Re: FortisBC Energy Inc. (FEI)

2022 Long Term Gas Resource Plan (LTGRP) – Project No. 1599324

Response to the British Columbia Utilities Commission (BCUC) Information Request (IR) No. 2

Figure 3: ITS Traditional Peak Demand Comparison

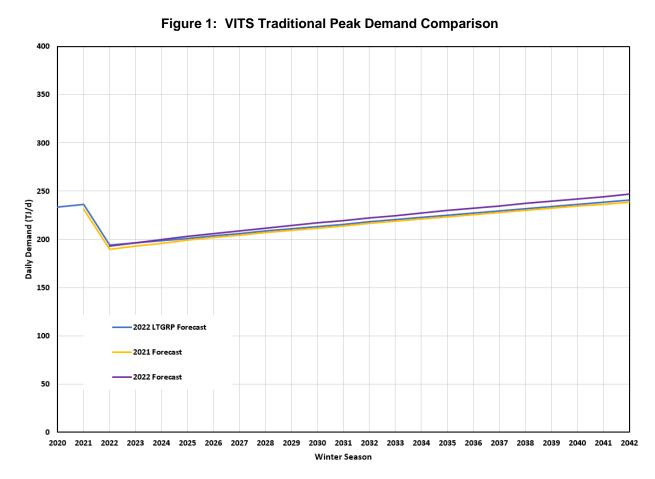
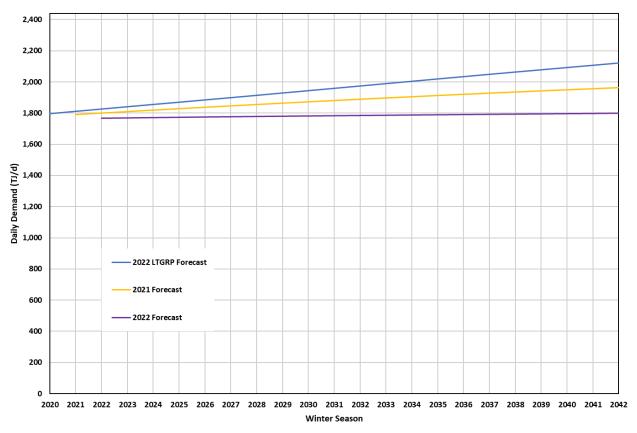
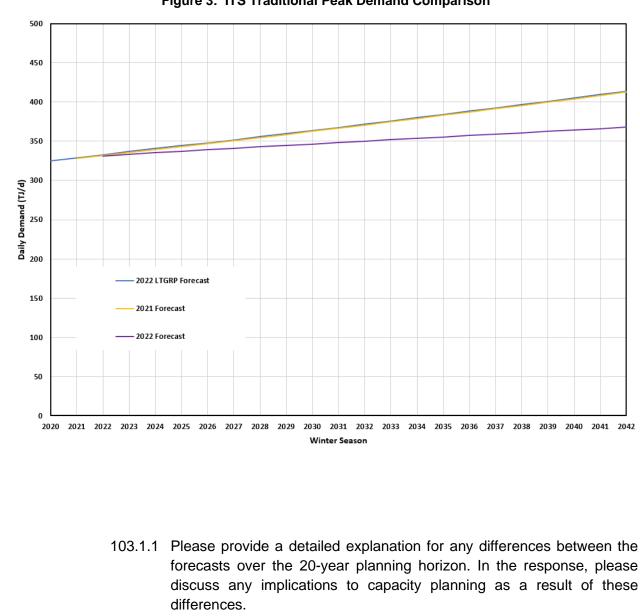
103.0 Reference: SYSTEM RESOURCE NEEDS AND ALTERNATIVES 1 2 Exhibit B-6, BCUC IRs 54.6, 54.7.2, **Traditional Peak Demand Forecast** 3 4 In response to BCUC IR 54.6, FEI states: 5 The base year for the peak demand forecast was 2019 (referred to as the 202 6 peak demand forecast). Customers attached on or before December 31, 2019 7 were accounted for in base demand and values for 2020, and future years included 8 the peak demand of forecasted account additions. 9 In response to BCUC IR 54.7.2, FEI states: FEI produces a peak demand forecast each year for each transmission system. 10 FEI's most recent completed forecast for each system is the 2021 forecast (based 11 12 on 2020 year-end customer attachments in all areas). FEI expects that the 2022 13 forecast (based on 2021 year-end customer attachments) will be completed by 14 mid-December 2022.

22 The requested figures modified to add the 2022 peak demand forecast are reproduced below.

Revised Figure 8 of FEI's Stage Two Energy Scenarios Submission – Cumulative Rate Impact (2022 – 2042) – Large Commercial RS 3

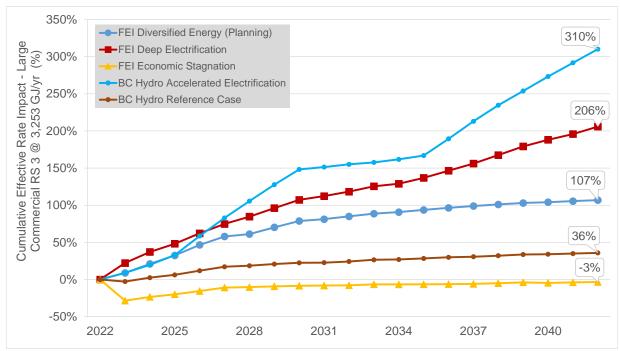
31 Additionally, while responding to this IR, FEI discovered the rate impacts shown in Figures 7 and 32 8 of FEI's Stage Two Submission on FEI and BC Hydro Energy Scenarios⁵⁹ were incorrect. Specifically, the rate impacts for BC Hydro's Accelerated Electrification scenario for the small 33 34 commercial and large commercial rate schedules were shown incorrectly due to excel errors. The 35 2024 cumulative rate impact for the small commercial RS 2 and large commercial RS 3 should 36 have been 304 percent and 310 percent, respectively. FEI confirms the rate impacts shown for 37 other scenarios in Figures 7 and 8 are correct. FEI also confirms the rate impacts shown in

- 1 Figures 6 and 9 of the Stage Two Energy Scenarios Submission are correct for the residential
- and general firm service rate schedules, respectively. FEI provides the revised Figures 7 and 8
 below.
- 4 5
